# Access Compliance Report

## Public Rights-of-Way

### (Curb Ramps)

Intersection ID: 4670	Main Street: CHASEWIND_DR	Cross Street: CONNER_RIDGE_LN	Location: NE
ADA ID: A755E64F18C2	Ramp Type: Perp	Initial Pass/Fail: Fail	Overall Compliance: No
Codes/Mitigation Info/Possible Solution		Field Measurements/Component Compliance

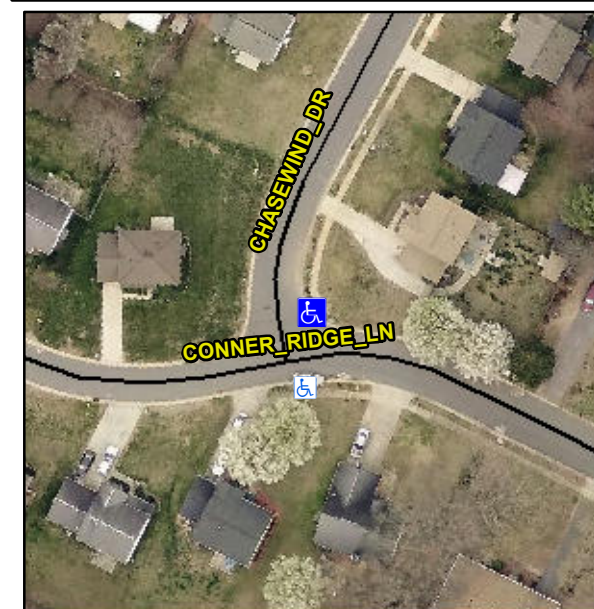
**Not Found, R304.2.2**

Compliance	Description	Data	Compliance	Description	Data
N/A	Ramp Length (in)	48.0	No	Ramp Slope (%)	9.1
Yes	Ramp Width (in)	51.0	Yes	Ramp XSlope (%)	4.5
N/A	Flare Type LT	N/A	N/A	Flare Type RT	N/A
N/A	Flare Slope LT (%)	N/A	N/A	Flare Slope RT (%)	N/A
N/A	Flare Traversable LT?	N/A	N/A	Flare Traversable RT?	N/A
N/A	Landing Length (in)	N/A	N/A	DWS Provided?	N/A
N/A	Landing Width (in)	N/A	N/A	DWS Contrast?	N/A
N/A	Landing Slope (%)	N/A	N/A	DWS Length (in)	N/A
N/A	Landing X Slope (%)	N/A	N/A	DWS Full Width?	N/A
N/A	Landing Curb? (Y/N)	N/A	N/A	DWS Offset (in)	N/A
N/A	Shared Landing?	N/A			
N/A	Gutter Ponding?	N/A	N/A	Gutter Slope (%)	N/A
N/A	Gutter Lip Ht (in)	N/A	N/A	Gutter X Slope (%)	N/A
N/A	Painted X Walk1?	No	N/A	Painted X Walk2?	N/A
	X Walk 1 Direction	To S		X Walk 2 Direction	N/A
N/A	X Walk 1 Width (in)	N/A	N/A	X Walk 2 Width (in)	N/A
	X Walk 1 Slope (%)	3.2		X Walk 2 Slope (%)	N/A
	X Walk 1 X Slope (%)	7.2		X Walk 2 X Slope (%)	N/A

**Remove & Replace Entire Ramp.**
